# Access Compliance Report

## Public Rights-of-Way

Intersection ID: 4986	Main Street: CELOSIA_DR	Cross Street: MORNING_GLORY_DR	Location: NE
ADA ID: 57C8E63E3BB4	Ramp Type: Perp	Initial Pass/Fail: Fail	Overall Compliance: No
Severity Score: 22.5			
Codes/Mitigation Info/Possible Solution		Field Measurements/Component Compliance

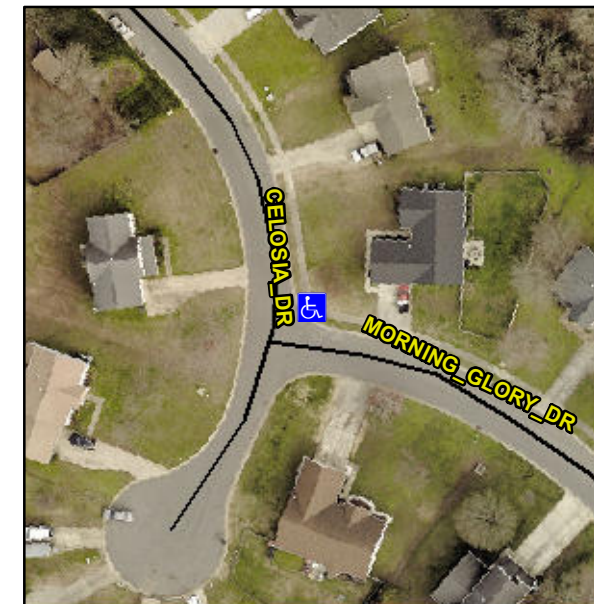
**R304.5.1, R304.2.2, R304.5.3**

Compliance	Description	Data	Compliance	Description	Data
N/A	Ramp Length (in)	51.0	No	Ramp Slope (%)	9.5
No	Ramp Width (in)	46.0	No	Ramp XSlope (%)	2.1
N/A	Flare Type LT	N/A	N/A	Flare Type RT	N/A
N/A	Flare Slope LT (%)	N/A	N/A	Flare Slope RT (%)	N/A
N/A	Flare Traversable LT?	N/A	N/A	Flare Traversable RT?	N/A
N/A	Landing Length (in)	N/A	N/A	DWS Provided?	N/A
N/A	Landing Width (in)	N/A	N/A	DWS Contrast?	N/A
N/A	Landing Slope (%)	N/A	N/A	DWS Length (in)	N/A
N/A	Landing X Slope (%)	N/A	N/A	DWS Full Width?	N/A
N/A	Landing Curb? (Y/N)	N/A	N/A	DWS Offset (in)	N/A
N/A	Shared Landing?	N/A			
N/A	Gutter Ponding?	N/A	N/A	Gutter Slope (%)	N/A
N/A	Gutter Lip Ht (in)	N/A	N/A	Gutter X Slope (%)	N/A
N/A	Painted X Walk1?	No	N/A	Painted X Walk2?	N/A
	X Walk 1 Direction	To S		X Walk 2 Direction	N/A
N/A	X Walk 1 Width (in)	N/A	N/A	X Walk 2 Width (in)	N/A
	X Walk 1 Slope (%)	6.0		X Walk 2 Slope (%)	N/A
	X Walk 1 X Slope (%)	2.3		X Walk 2 X Slope (%)	N/A

**Remove & Replace Entire Ramp.**
